Landscape Review Committee Community Development Center, 231 NE 5th Street June 20, 2018 12:00 PM

FROM: Chuck Darnell, Senior Planner SUBJECT: Agenda Item 4A: L 14-18

DECISION, CONDITIONS OF APPROVAL, FINDINGS OF FACT, AND CONCLUSIONARY FINDINGS OF THE MCMINNVILLE LANDSCAPE REVIEW COMMITTEE FOR APPROVAL OF LANDSCAPE PLAN FOR A NEW BUILDING AT THE YAMHILL COUNTY FAIRGROUNDS

FROM: Chuck Darnell, Senior Planner SUBJECT: Agenda Item 4B: L 16-18

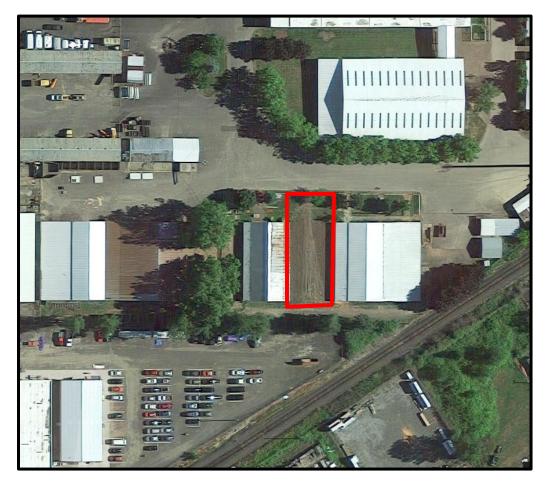
The landscape plan as proposed includes the retention of grass area in front of the barn, which is consistent with the treatment of the areas in front of the row of barns that the new barn will be constructed within. The applicant is proposing to install one (1) Red Mountain Hydrangea (*Hydrangea serrata* 'Red Mountain') within the grass area. This shrub will grow to be 2-3 feet wide and 2-3 feet high. The applicant is also proposing to maintain a white vinyl picket fence that exists along the entire length of the landscaped area in front of the row of barns.

In each of the other landscaped areas in front of the adjacent barns, there is at least one (1) tree. There are a variety of different species of trees, including fir, cherry, and maple species. To be more consistent with this planting pattern, staff is suggesting a condition of approval be included to require that one (1) tree be planted in the center of the grass area being proposed in front of the new barn building. Staff also suggests that the tree species be either a flowering cherry or maple variety.

With the addition of the tree in the landscaped area, the proposed landscape plan will be compatible with the proposed project and the abutting uses.

- 1. That the applicant shall install landscaping as shown on the landscape plan submitted on May 7, 2018.
- 2. That the applicant shall install one tree in the center of the landscaped area proposed to be located in the front of the new barn building. The tree species shall be a flowering cherry (*Prunus sargentii*) or Red Maple (*Acer rubrum*) variety.

NORTH GROUP BLDG. 1-3 UNITS 1-6

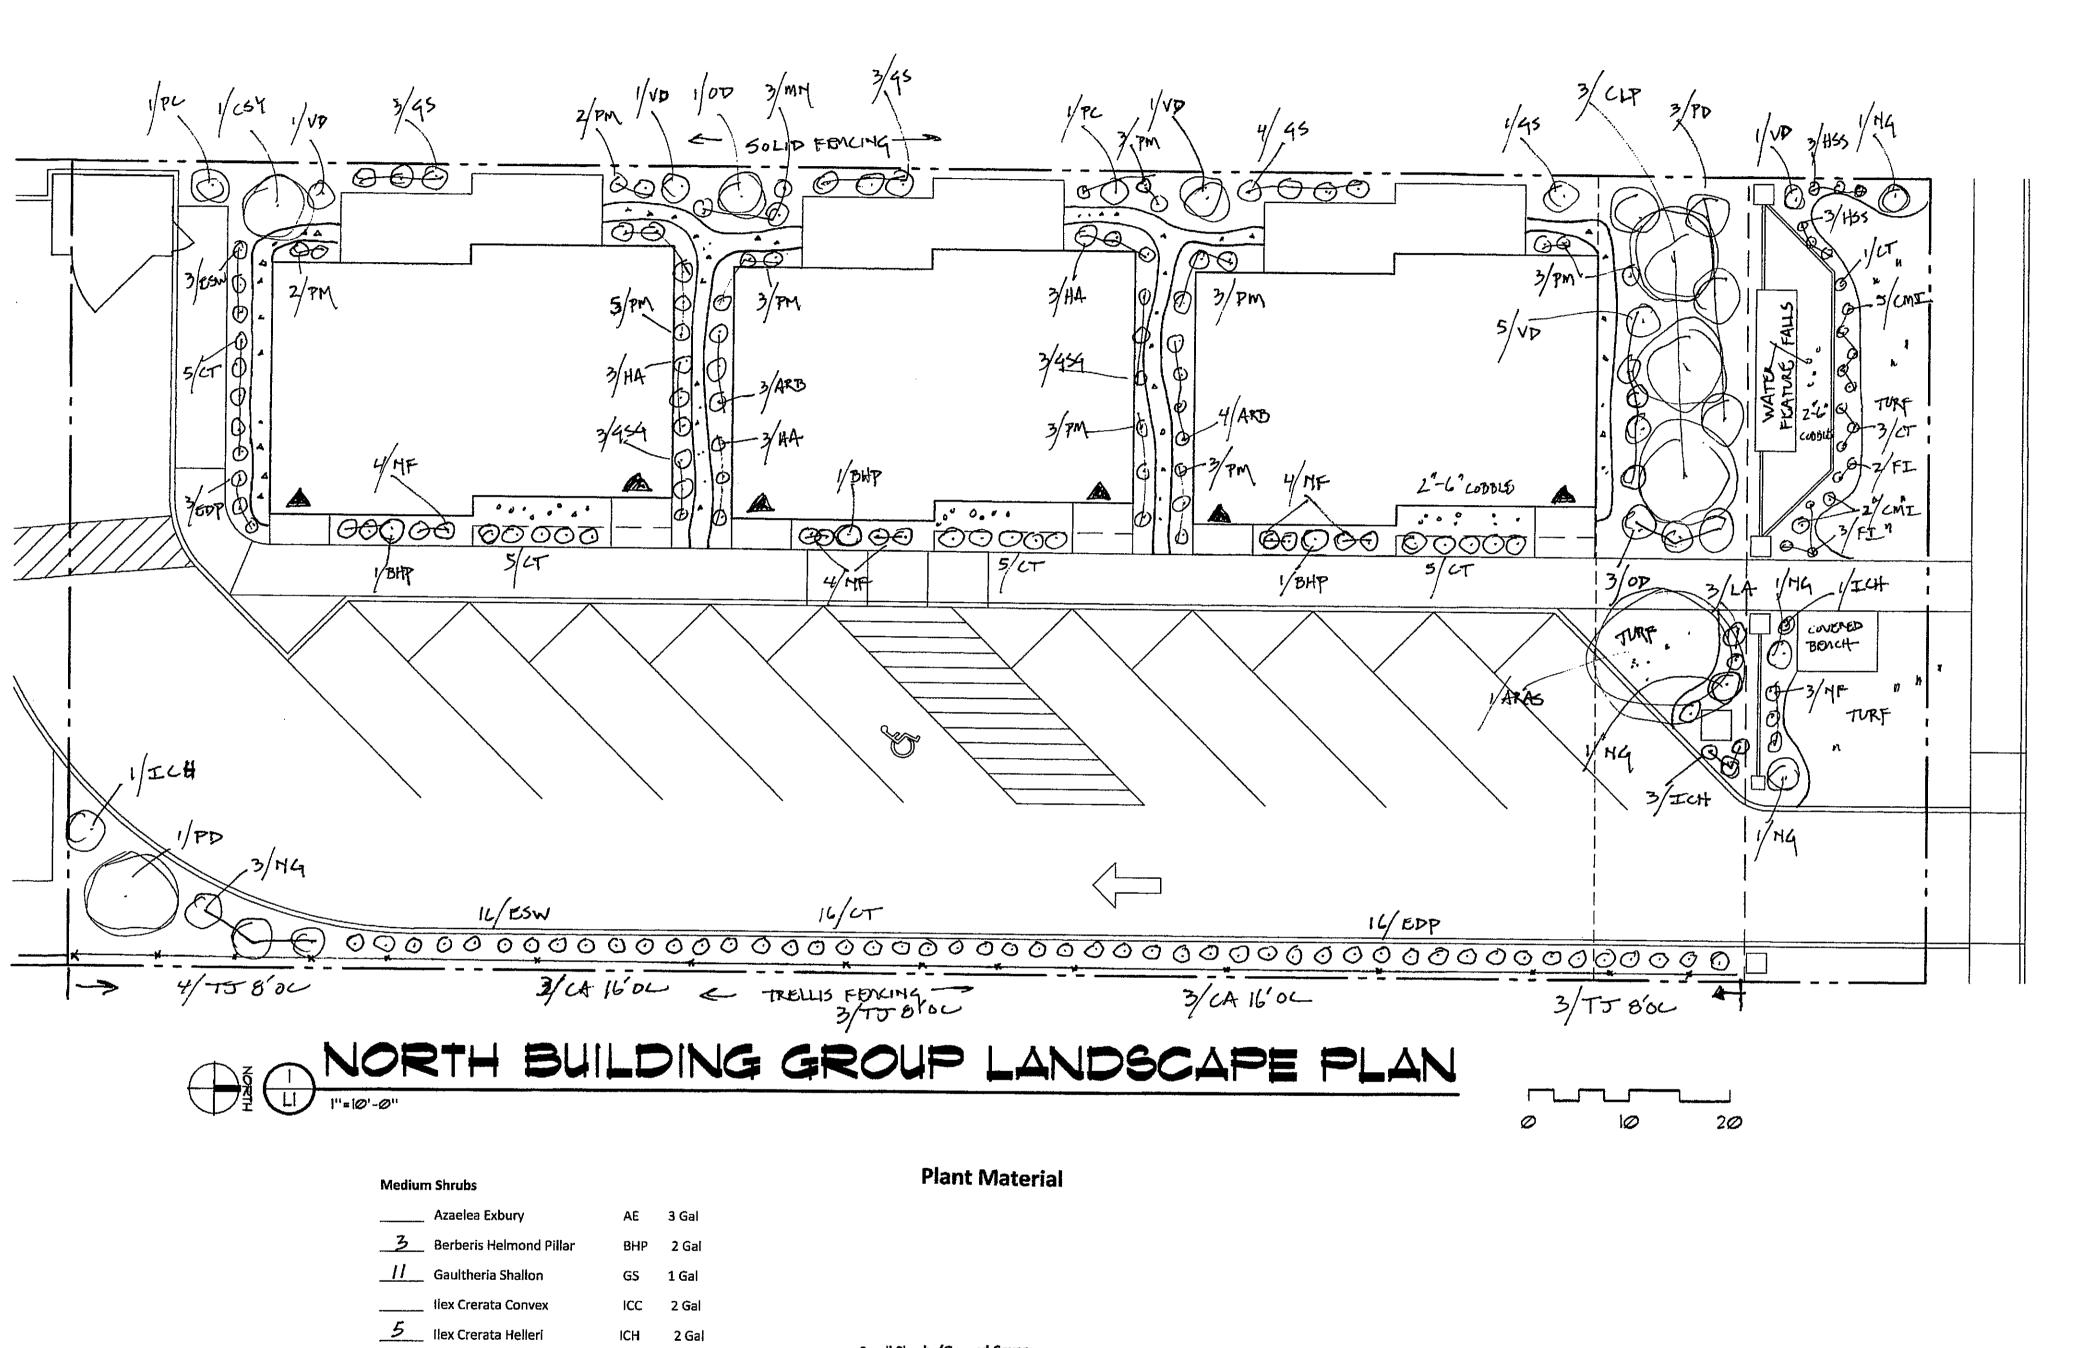
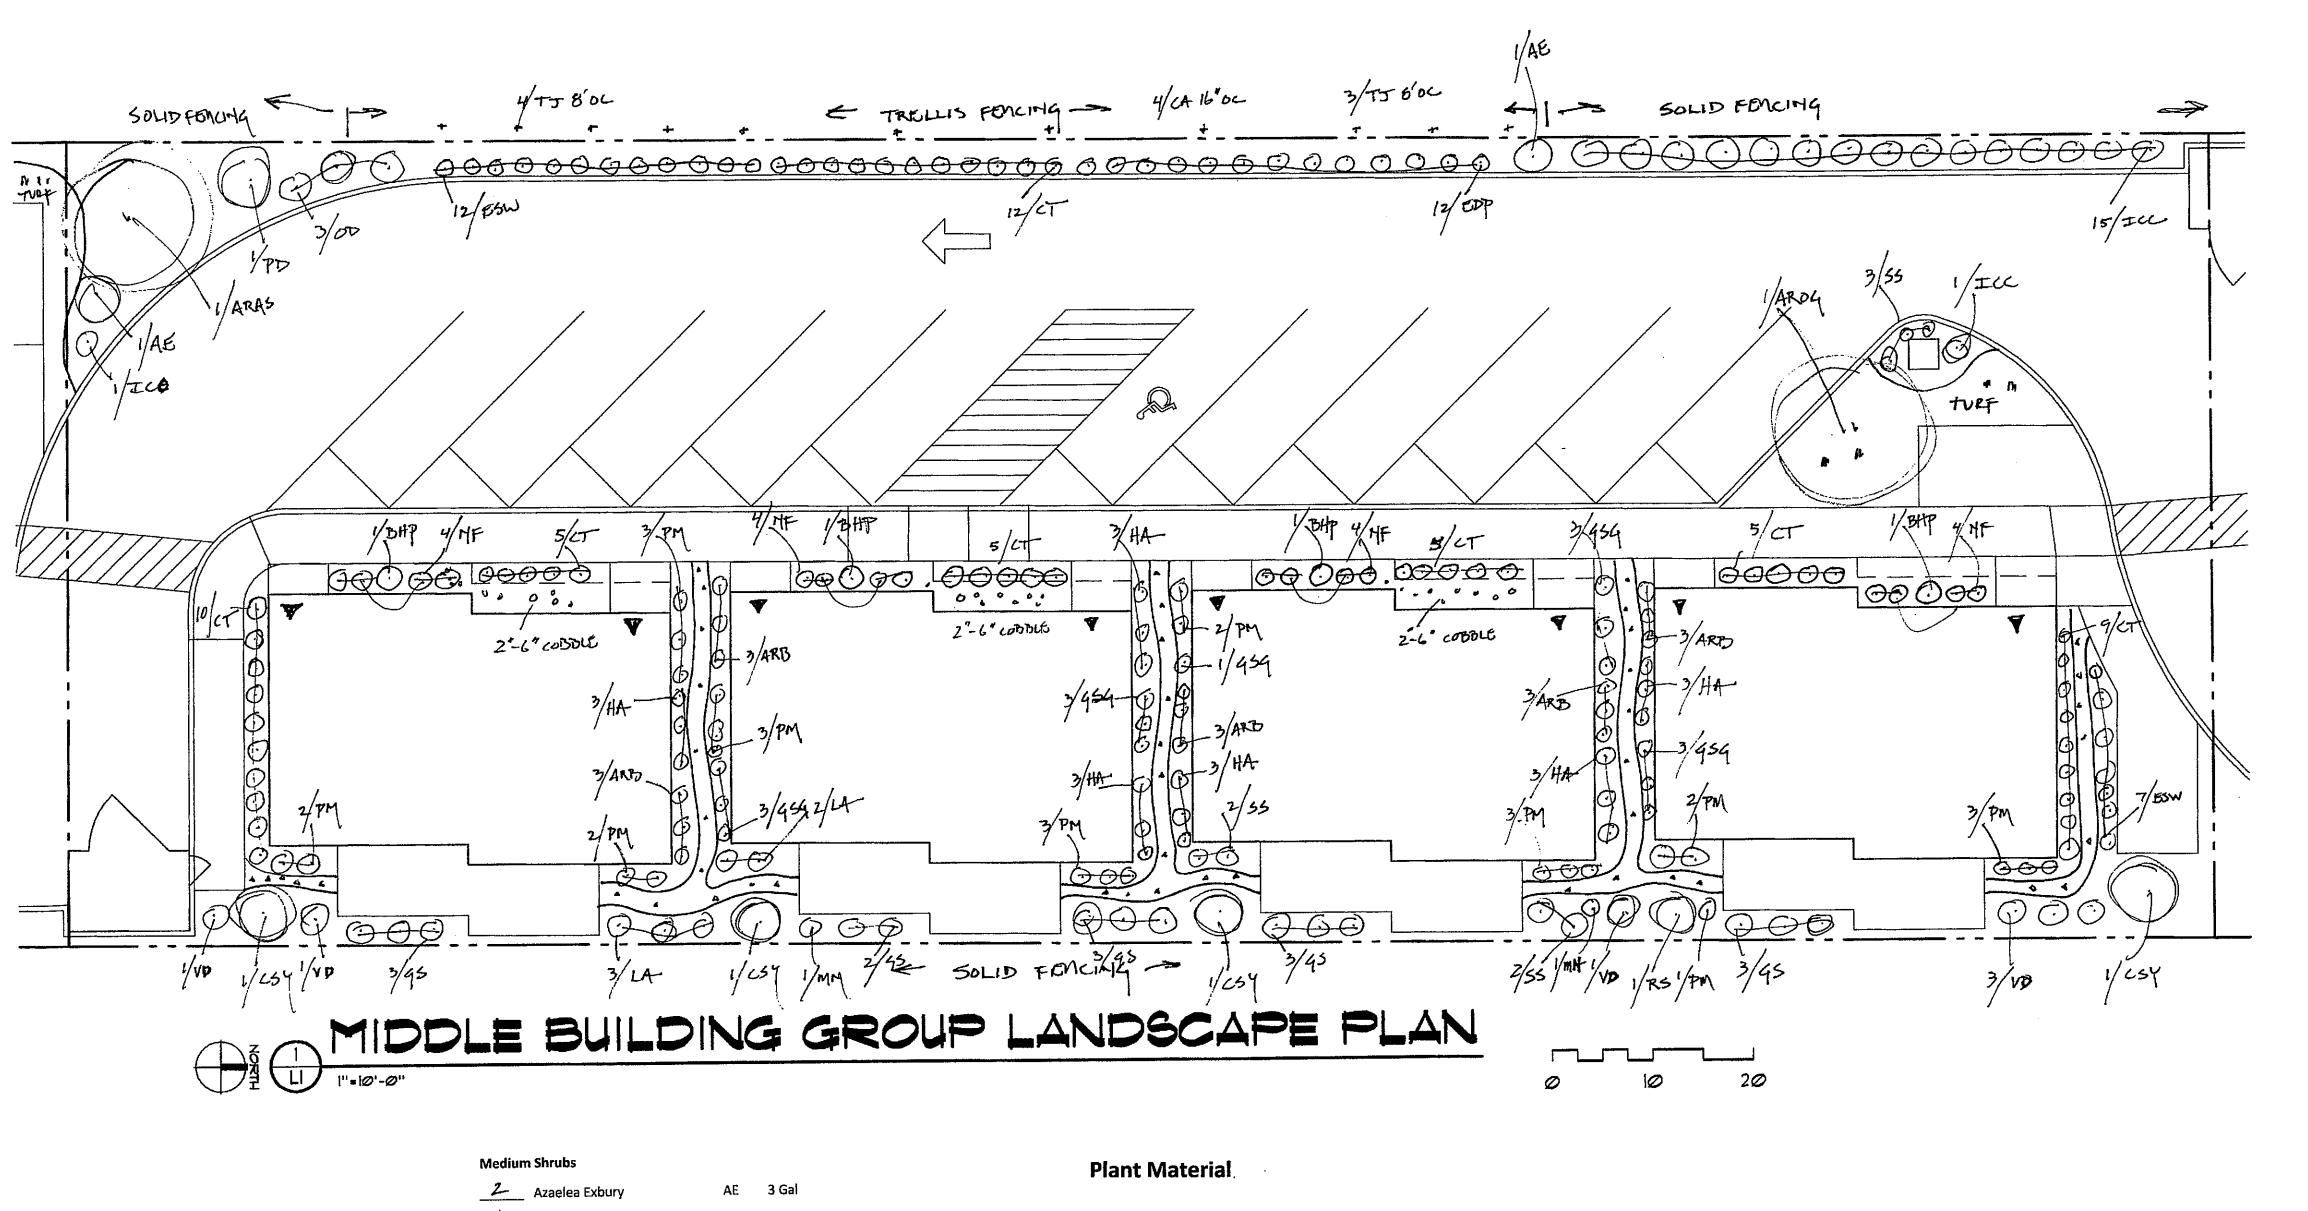
The landscape plan as proposed includes a wide variety of trees, shrubs, grasses, and vines, as well as other groundcover and accent features. In general, the development site is very narrow, with a meandering one-way access driveway that runs through the site. There is a narrow planting strip on the side of the driveway closest to the property lines is proposed to be treated with trellis fencing. In the planting strip, which is about 4 feet wide, the applicant is proposing an alternating pattern of multiple varieties of Heather (*Erica* 'Mediterranean Pink' and *Erica* 'Springwood White'), New Zealand hair sedge (*Carex Testacea*), and Japanese Holly (*Ilex Crenata* 'Convexa'). Also, adjacent to the trellis fencing, the applicant is proposing to install vines periodically that will grow up and cover the fencing. These vines include Evergreen Clematis (*Clematis aramandii*) and Jasmine (*Trachelospernum Jasmiodes*).

On the 2nd Street frontage, the applicant is proposing a significant amount of landscaping. Included in the plan is a water fall feature with stone surround, and then surrounded further by small shrubs and grasses. The shrubs include David Viburnum and Heavenly Bamboo, and the grasses include Carex M. 'Ice Dance' sedge and New Zealand hair sedge (*Carex Testacea*). Turf grass will then be installed between the planting bed and the public sidewalk. Behind the water feature, the plan includes the installation of three Blue Atlas Cedar (*Cedrus libani* 'Pendula') trees and one Autumn Spire Red Maple (*Acer rubrum* 'Autumn Spire') tree, with a variety of shrubs in the understory.

Around the individual buildings, the applicant is proposing a wide variety of shrubs and grasses. The shrubs include multiple varieties of Heavenly Bamboo, multiple varieties of Japanese Holly, David Viburnum, Pierus 'Cavatine', Western swordfern (*Polystichum Munitum*), and Salal (*Gauitheria Shallon*). The shrubs will be planted in beds in the front of the building between the entries to each unit, along the sides of each unit, and in the rear of the buildings around the cement patios. Walkways

The proposed landscaping in the narrow planting strip adjacent to the driveway, including Erica shrubs, grasses, and vines adjacent to a trellis fence, will provide for the required buffering from headlight glare and visual intrusion in those locations where there will be more vehicular traffic. The plan includes solid fencing in the locations that are along the rear side of the buildings. There will also be continuous rows of shrubs along the solid fenceing in almost all locations. These shrubs will include Vaccinum corymbosum, Pierus 'Cavatine', Mahonia nervosa, and Salal. These variety of shrubs will provide for both some taller vegetation, as well as some lower growing shrubs. The combination of medium and small shrubs, along with the solid fencing, will provide for screening of the cement patio spaces from the adjacent single family residential uses.

- 1. That the applicant shall install landscaping as shown on the landscape plan submitted on May 23, 2018.
- 2. That the applicant shall maintain proper clearances around the existing and future water and electrical services that will be located on the site. Landscaping shall not be placed within four (4) feet of fire hydrants, within four (4) feet of water valves, within four (4) feet of vaults, within three (3) feet of the back or side of a transformer, or within one (1) foot of water meters. Minor adjustments in plant placement from the locations shown on the approved landscape plan are allowed if relocation is necessary to meet minimum clearances.
